RE: HIWAY HOUSE 3200 Central Ave SE

Conceptual Grading & Drainage Plan

Engineer's Stamp Date: 1/8/25 Hydrology File: K16D055

3200 CENTRAL AVE SE ALBUQUERQUE, NM	<i>DRAWN BY</i> pm
	CONCEPTUAL GRADING PLAN	<i>DATE</i> 1–8–25
		DRAWING
		SHEET #
5	TIERRA WEST, LLC 5571 MIDWAY PARK PL NE ALBUQUERQUE, NEW MEXICO 87109	GR-1
VAN	(505) 858-3100 www.tierrawestllc.com	<i>JOB #</i> 2024042

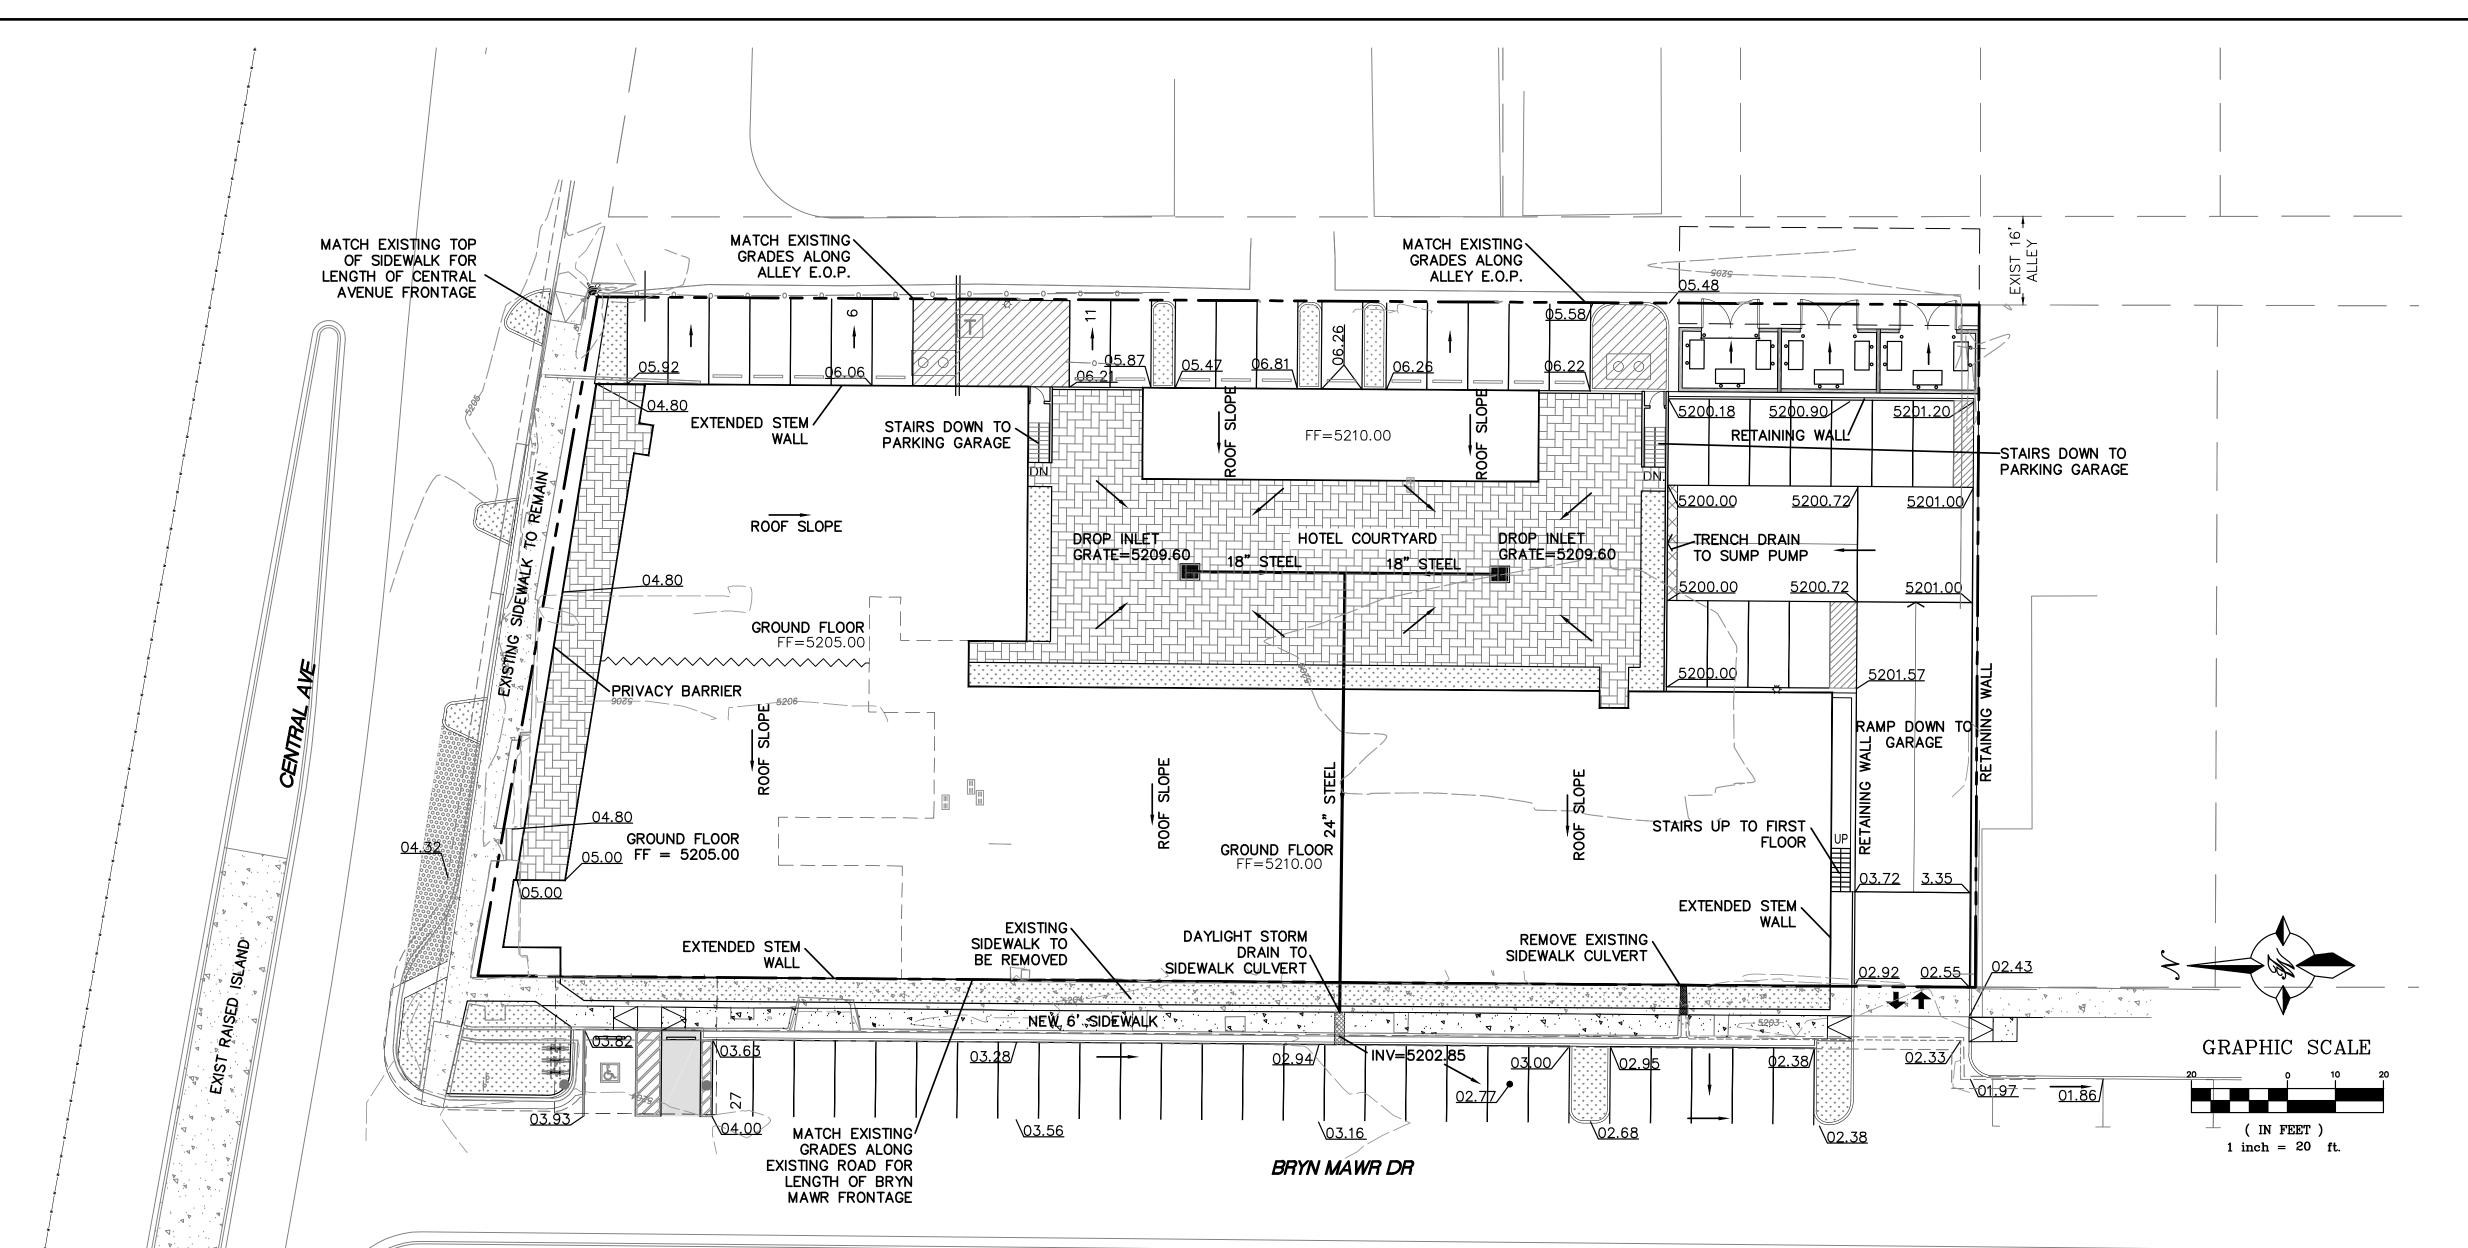
1. Please submit a more detailed Grading & Drainage Plan to Hydrology for review and approval. This digital (.pdf) is emailed to PLNDRS@cabq.gov along with the Drainage Transportation Information Sheet.

2. If requesting a Waiver of Management Onsite, the following conditions of the new drainage ordinance (enacted 10/2/18) must be demonstrated on the plan (§ 14-5-2-6 (H)):

Show where stormwater quality can be effectively controlled through private offsite mitigation, or through an arrangement to utilize a cooperator's existing regional stormwater management infrastructure or facilities that are available to control stormwater quality.

And where one (or more) of the following is met:

- the lot is too small to accommodate management on site while also accommodating the full plan of development;
- the soil is not stable;
- the site use is inconsistent with the capture and reuse of stormwater;
- other physical conditions exist where compliance with on-site stormwater quality control requirement leaves insufficient area;

- public or private off-site facilities provide an opportunity to effectively accomplish the mitigation requirements of this ordinance;
- there is an opportunity to develop a project to replenish regional ground water supplies at an offsite location; or
- a waiver to state water law or acquisition of water rights would be required in order to implement management on site.
- 3. If requesting a Waiver of Management Onsite, please add a note which states, "The Owner has elected to pay the Payment in Lieu for the required Stormwater Quality Volume."
- 4. If requesting a Waiver of Management Onsite, please show the Payment calculation on the plan. (Payment in Lieu = $XXXcf \times \$/cf = \X,XXX).
